SECTION 00 9112
ADDENDUM NUMBER 2

DATE: 03/02/2021
PROJECT: CITY OF MILLERSBURG FIRE STATION 15
ARCHITECT'S PROJECT NUMBER: 20006
OWNER: CITY OF MILLERSBURG
ARCHITECT: SODERSTROM ARCHITECTS

1 SOUTH ELEVATION

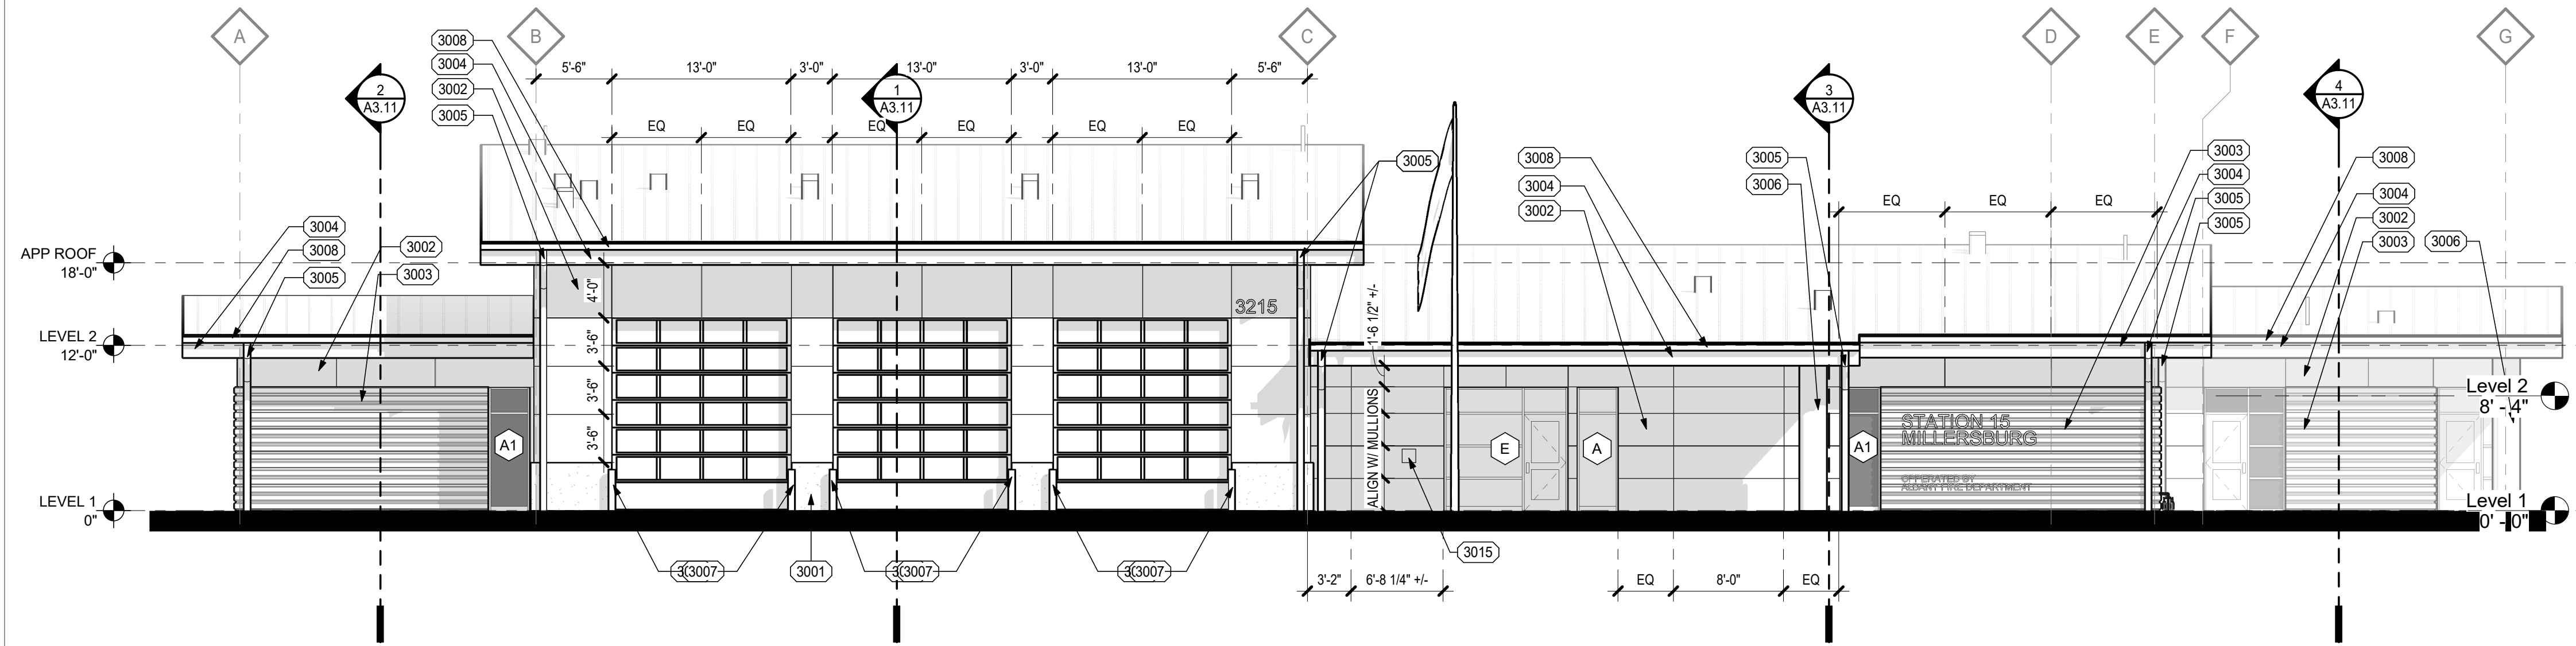
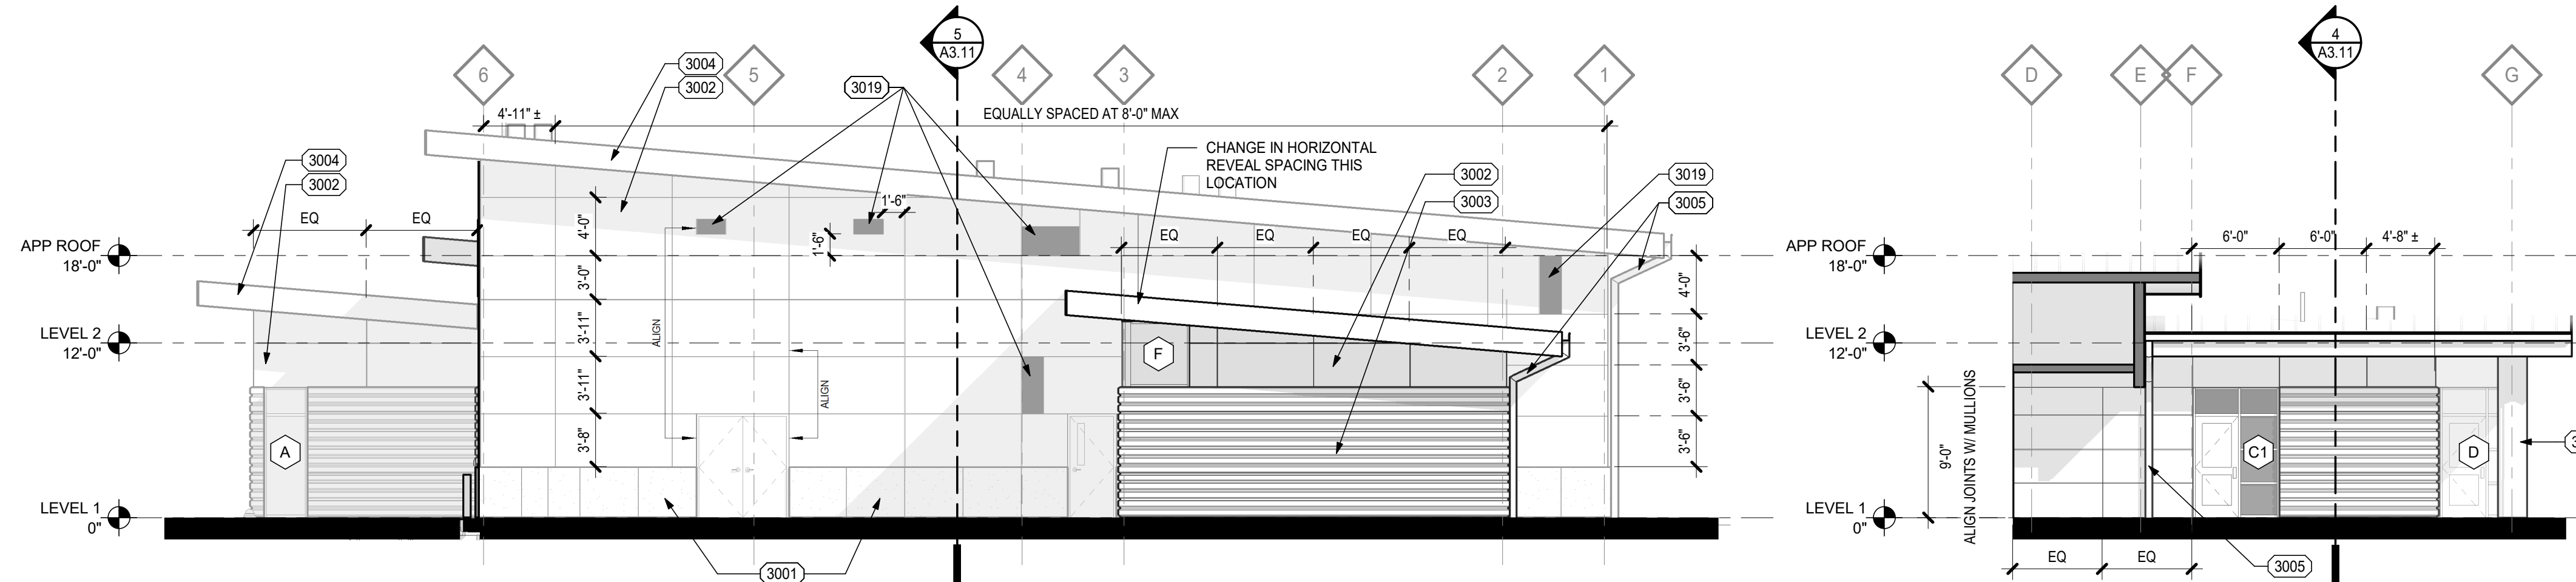
DRAWING A3.02

Revise Keynote 3004

- A. A 20" high LSL board will be used for fascia board at all locations. See revised details on A8.20 and revised Keynote 3004 on A3.01 and A3.02, reissued with this addendum.

1 OVERALL REFLECTED CEILING PLAN

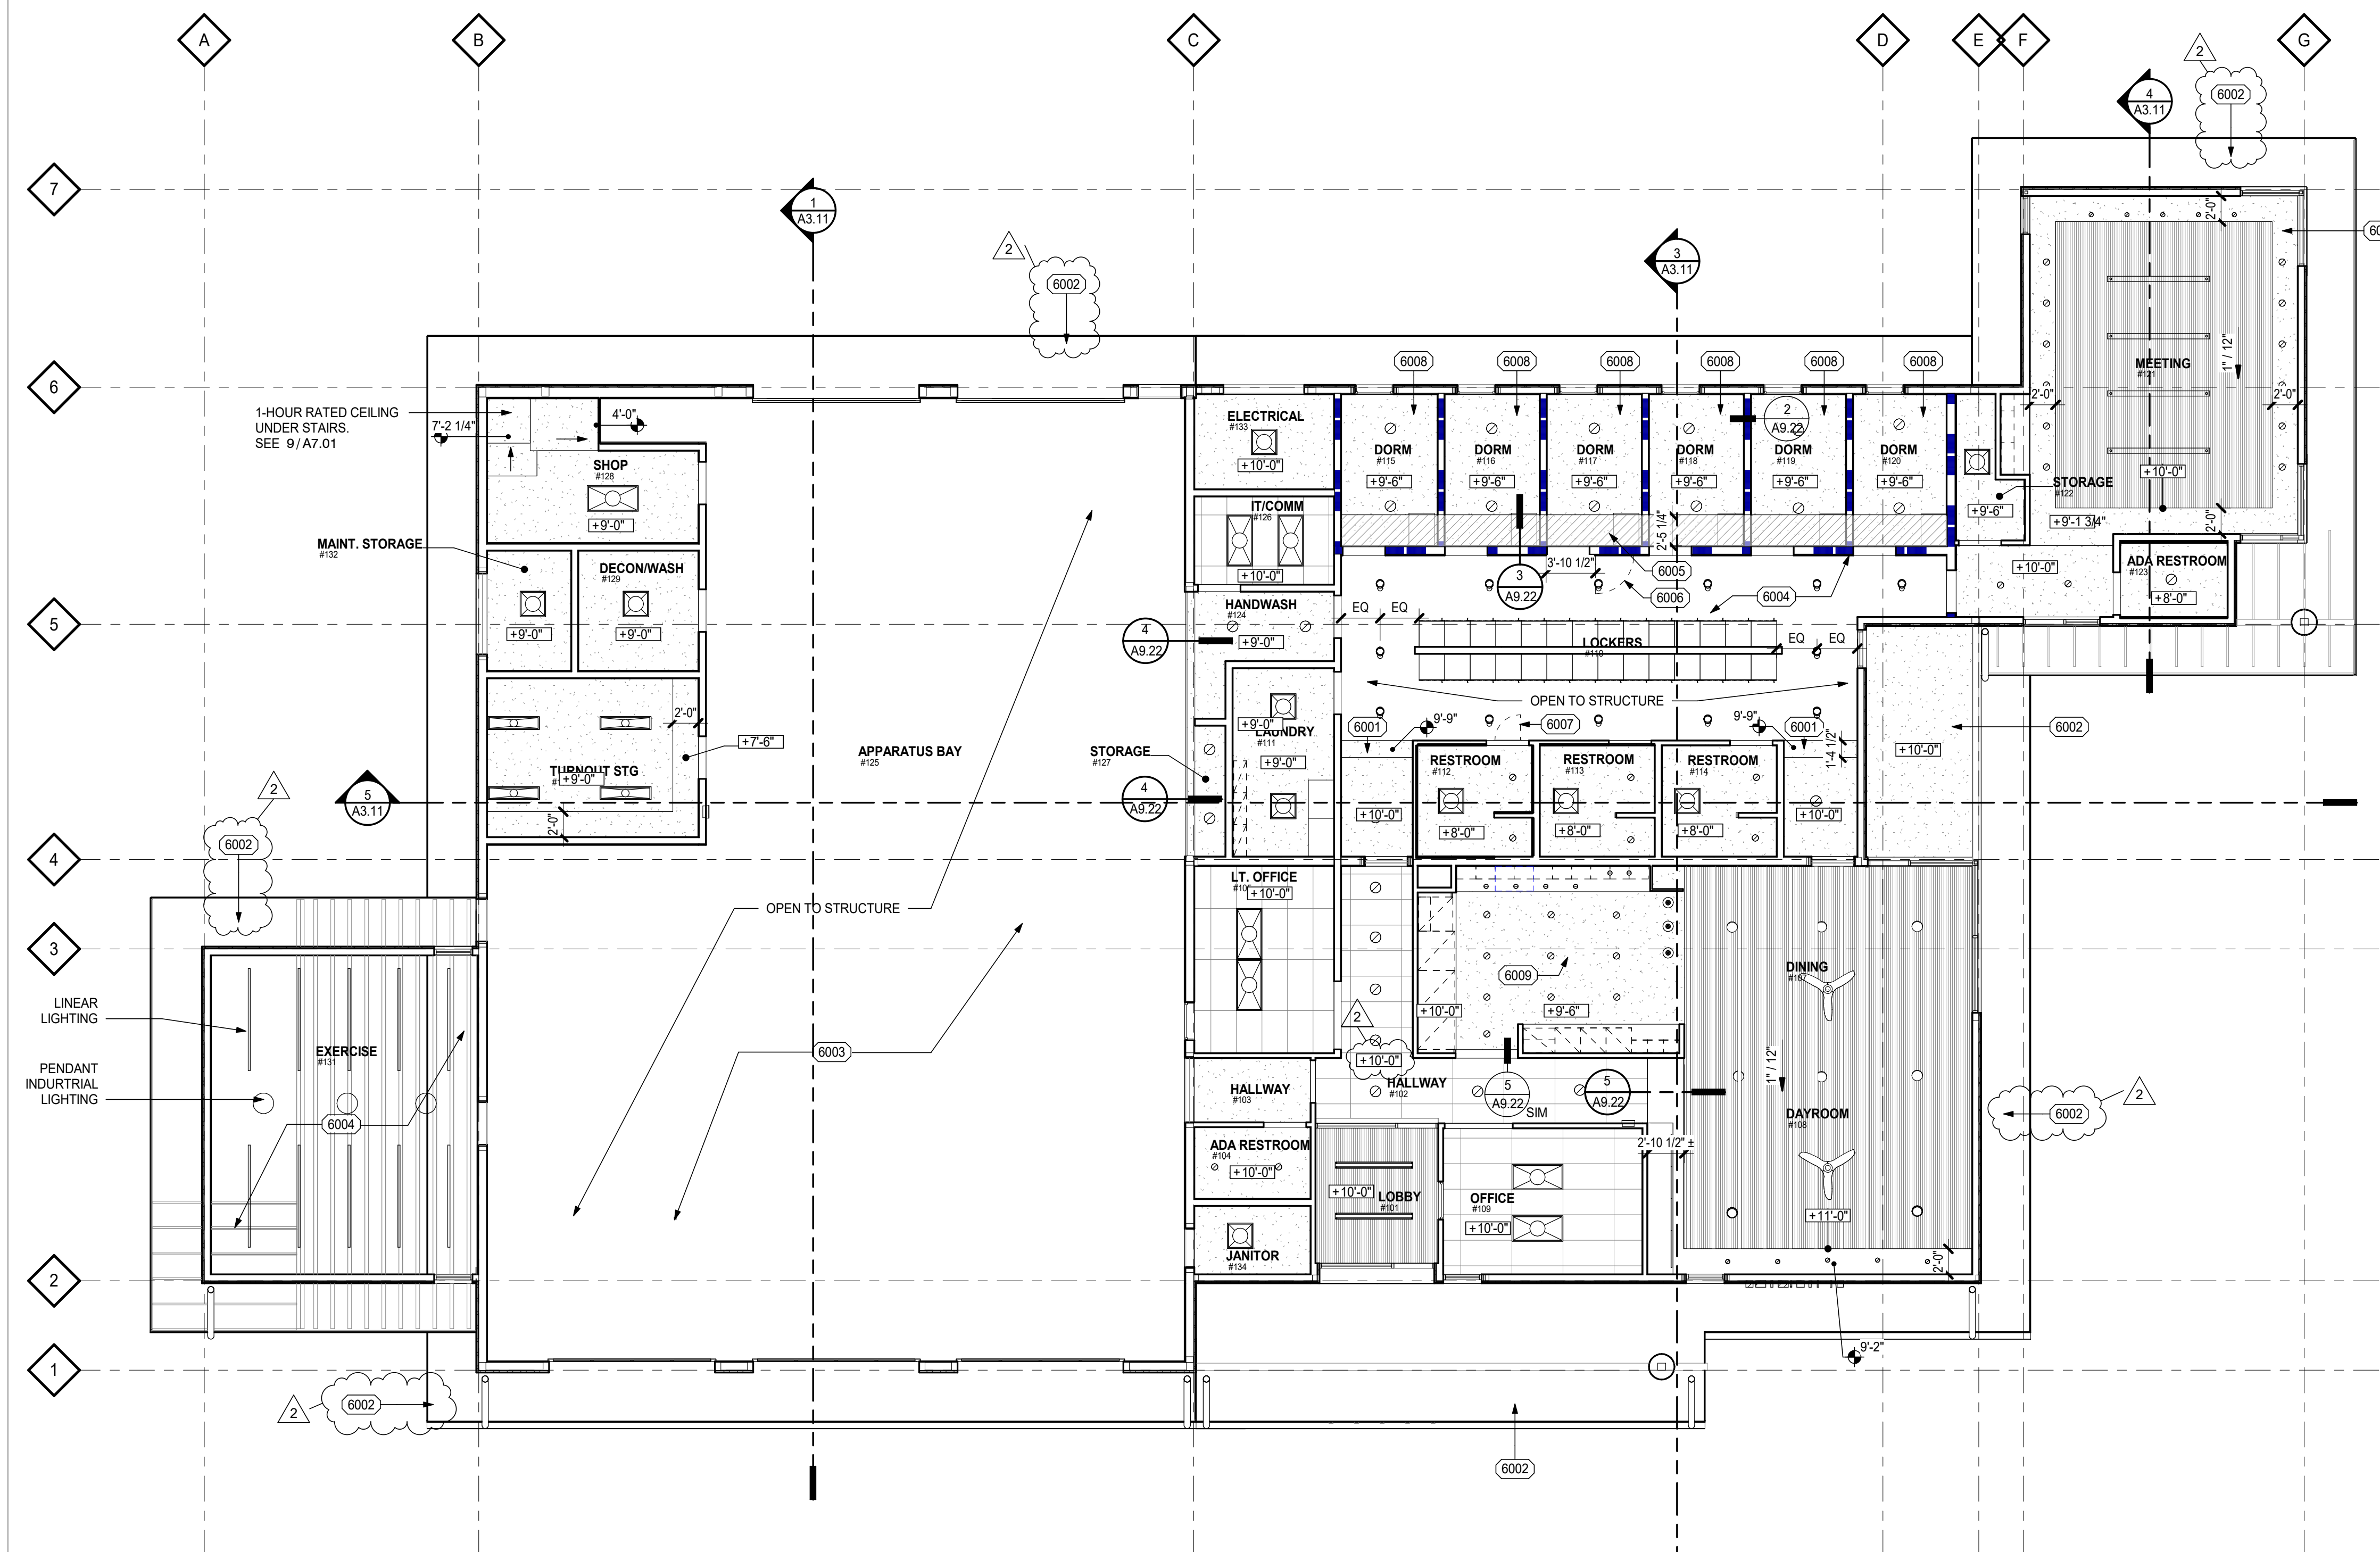
DRAWING A6.01

Added Note to sheet, as follows: Building section cuts were inadvertently not shown on the previously issued version of this drawing. Cuts have been added to plan. Since the sections themselves are not new information, these cuts have not been clouded in order to maintain legibility of drawing.

Added Building Section cuts as noted above

Revise to add additional instances of Keynote 6002, indicating all exterior soffits to be painted, Per Clouded Items, Delta 2

Revise to add ceiling height call-out at Hallway 102

- 26. Painting of Exterior Surfaces: Legend Keynotes do not specifically call-out painting of exterior surfaces like cement board soffits. A painting contractor called to ask if these surfaces paint. In the interest of clarity, please add keynotes related to painting of exterior surfaces.**

- 28. Please advise finish ceiling height of 2x4 grid system at Hallway 102.**
- A. Ceiling to be 10'-0" AFF. See revised A6.01 issued with addendum.
- 29. Detail 5/A9.22 appears to show a portion of the 2'-10-1/2"-wide gyp soffit along west edge of Room 108. Please show full width of 2'-10-1/2" wide soffit and how it relates to ACT system in Hallway 102 (same height?). Please also show location of 16" x 14" SA duct presumably located in soffit framing. Advise spacing of (4) SA diffusers if layout is critical.**

- A. Keynote 6002 indicates painting of soffits. Additional keynotes have been added to clarify that all exterior soffits are to be painted. See revised A6.01
